Re: 9/20/2021 Response to Second and Third Quarter 2020 Progress Report RTC Hess Corporation Former Port Reading Complex (HC-PR) 750 Cliff Road Woodbridge, Middlesex County, New Jersey NJDEP PI# 006148 ISRA Case No. E20130449 EPA ID No. NJD045445483

NJDEP Comments & Earth Systems/Hess Responses

FIGURE: 10

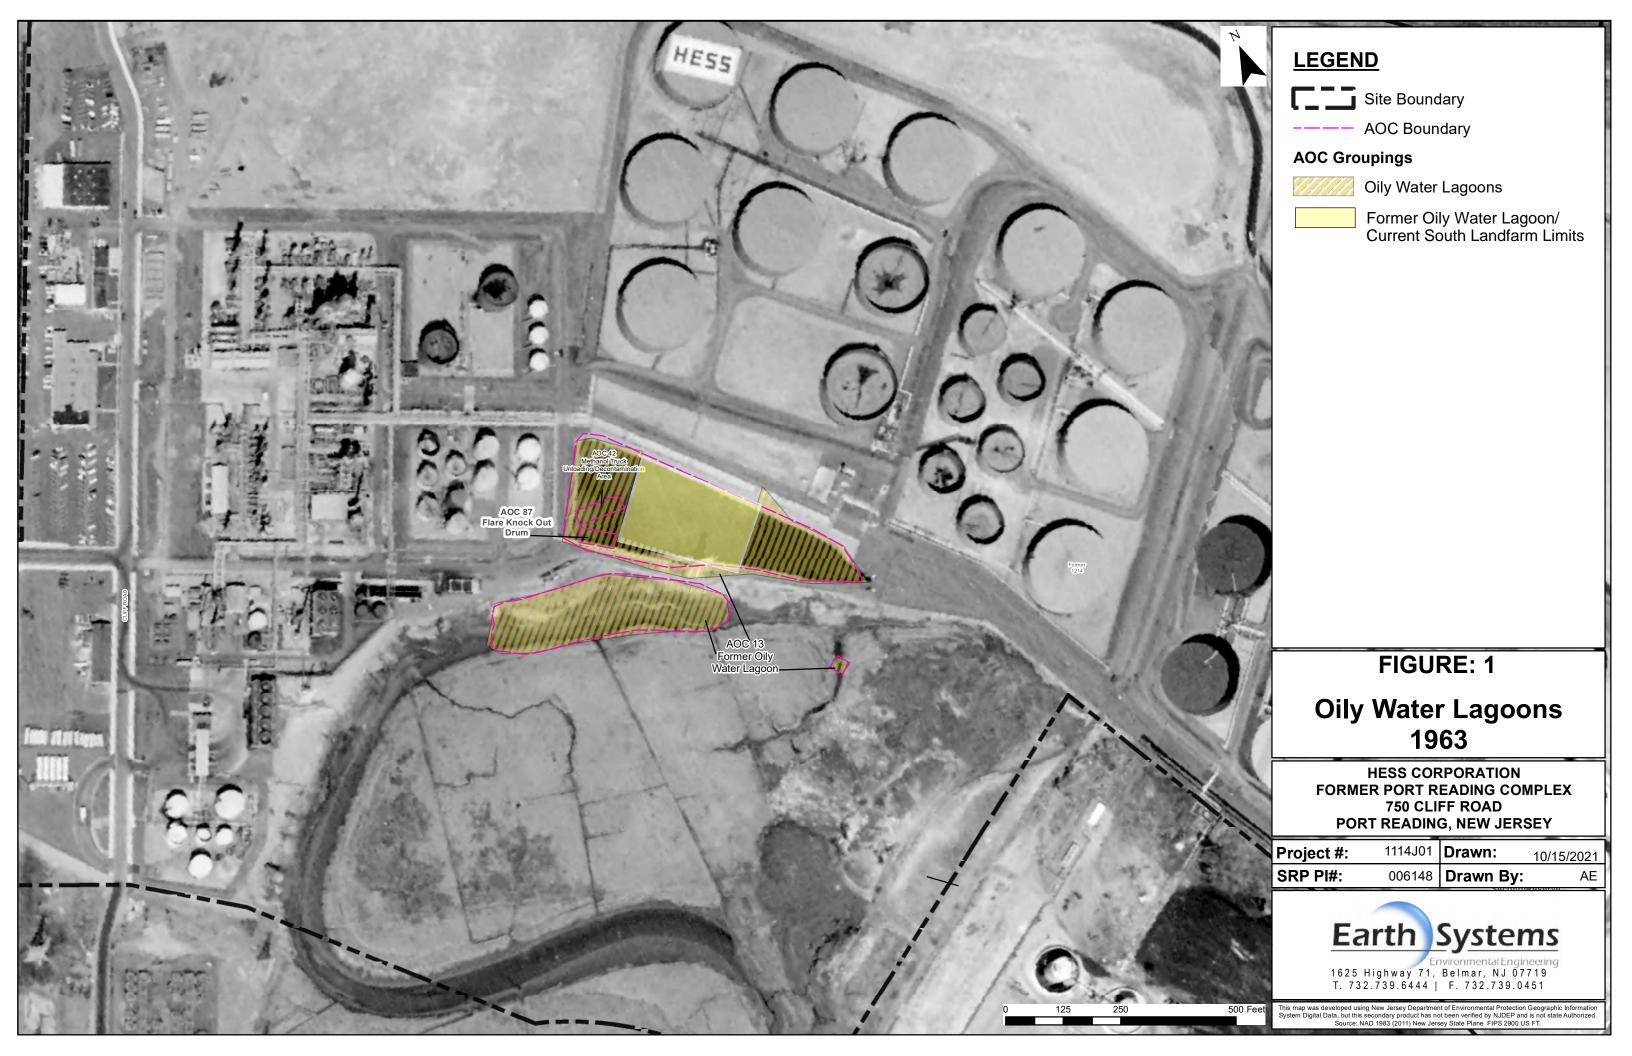
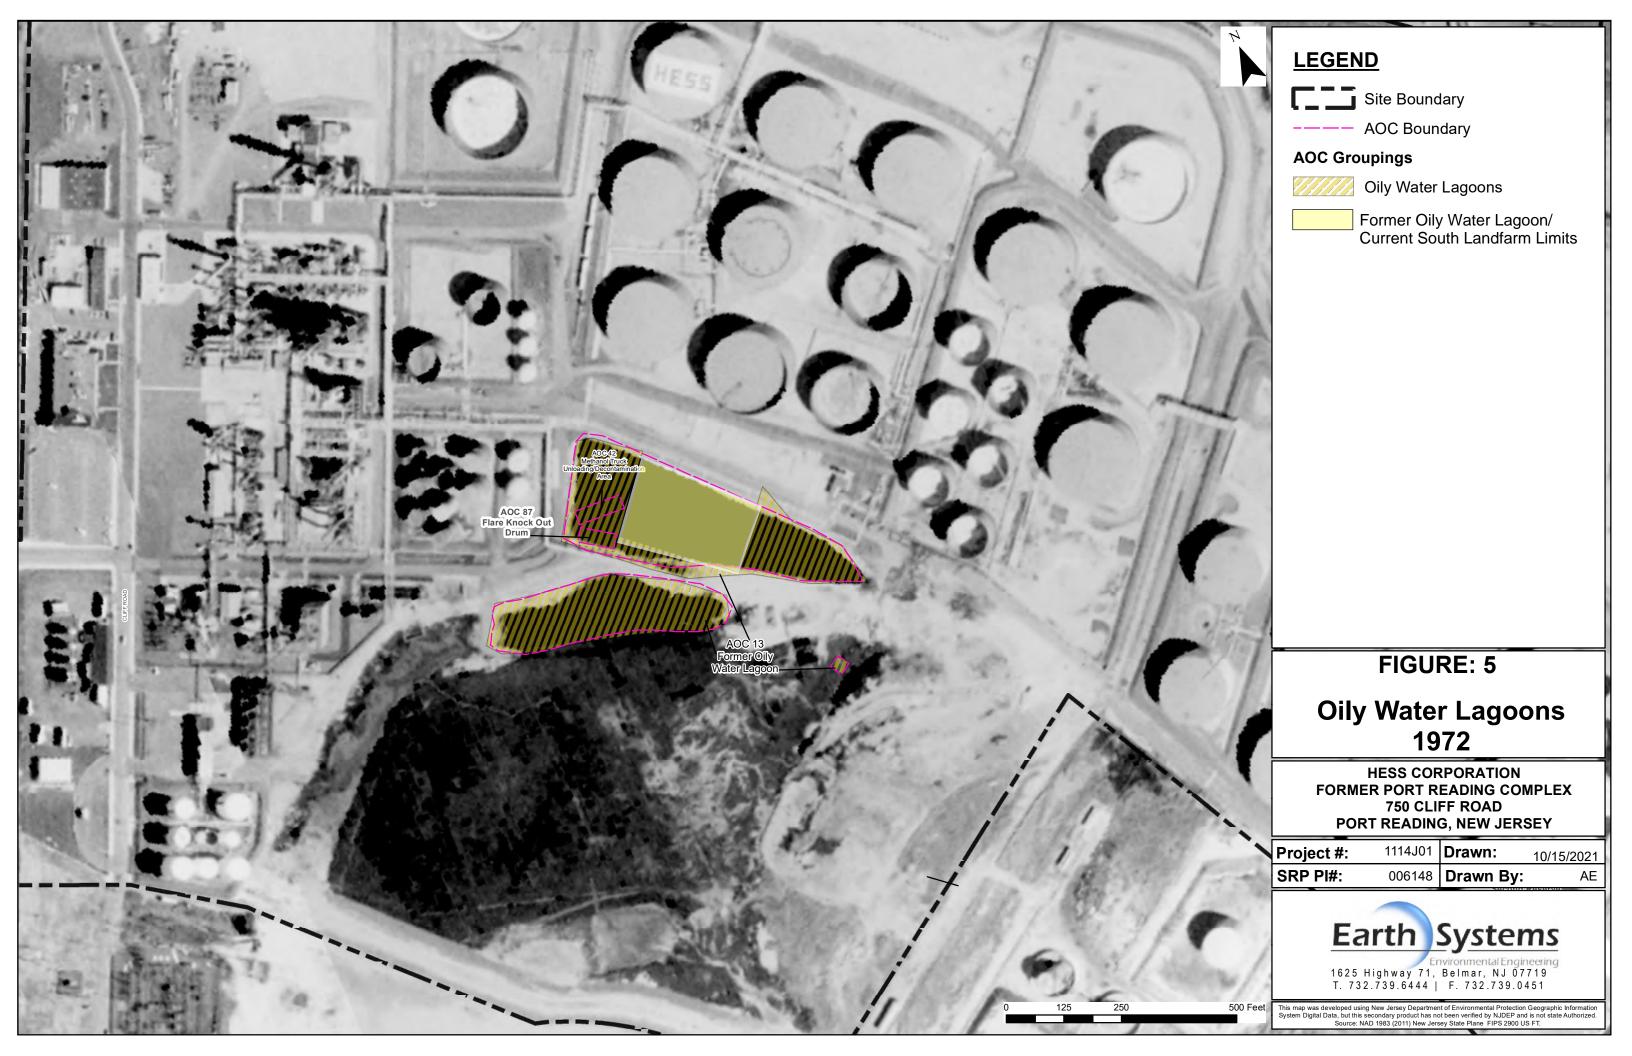
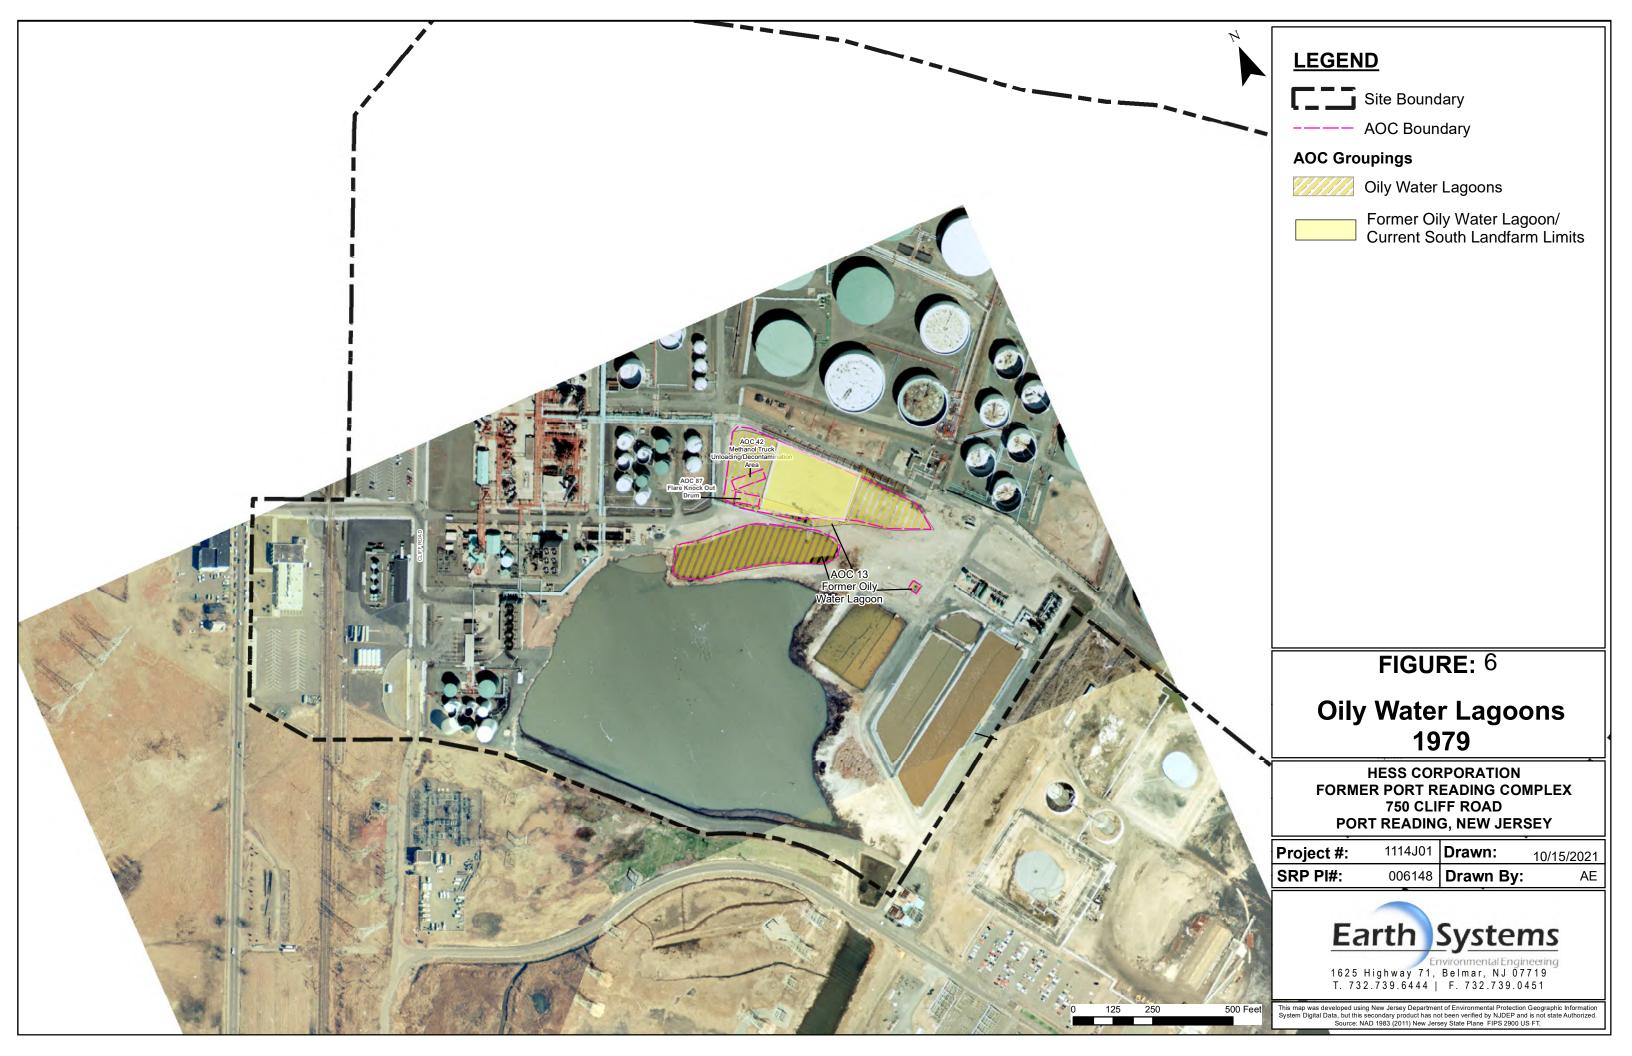
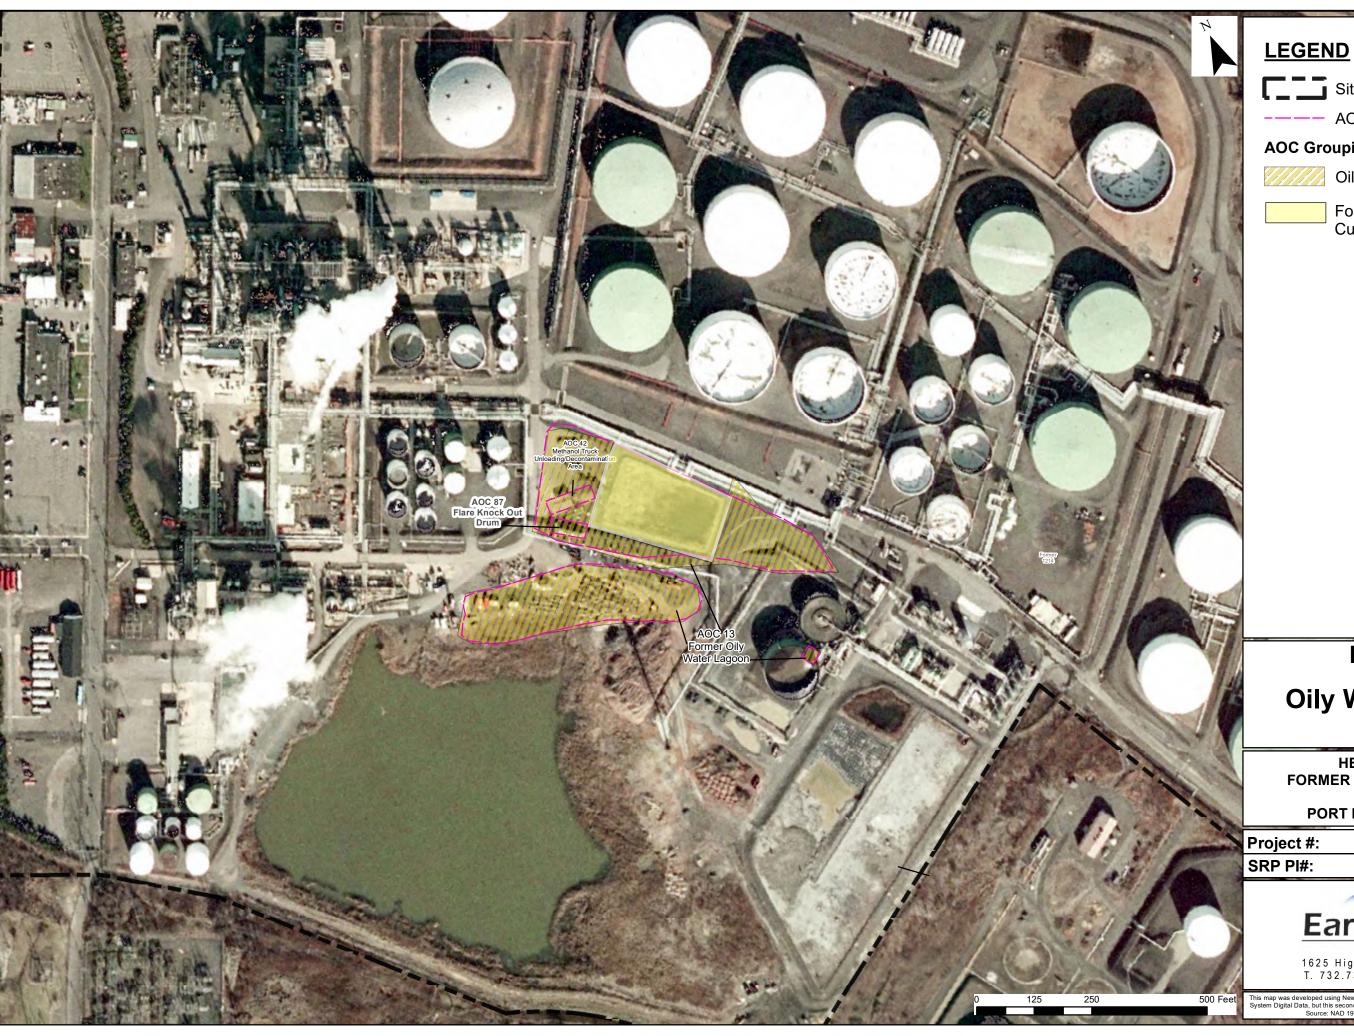
A. The response addresses the revision of the AOC 13 lagoon limits (oily-water lagoon, mini-lagoon, backwash lagoon). The response does not address the complete comment related to other features from the schematic that remain on site figures, and the actual location of the piping between the API Separator and the former treatment plant(s). Figures were not included with the response, therefore, future document figures will be reviewed. Note: the CSM figures did not include the backwash lagoon; future figures should include it.

B. Historic information (aerial photos) should be used to revise location AOC 78. The location of AOC 78 appears to be approximated and will have to be finalized. Note: the CSM figures for AOC 78 do not appear to be accurate.

<u>Earth Systems/Hess Response 10A:</u> Draft figures depicting AOC 13 lagoon limits have been included with this response. If these figures are approved by the NJDEP, this figure will be the figure used going forward with all submittals.

Earth Systems/Hess Response 10B: Draft figures depicting AOC 78 depicted over several historic aerial photographs have been included with this response. Once the NJDEP approves the location and depiction of AOC 78, the AOC outline will be permanently revised.
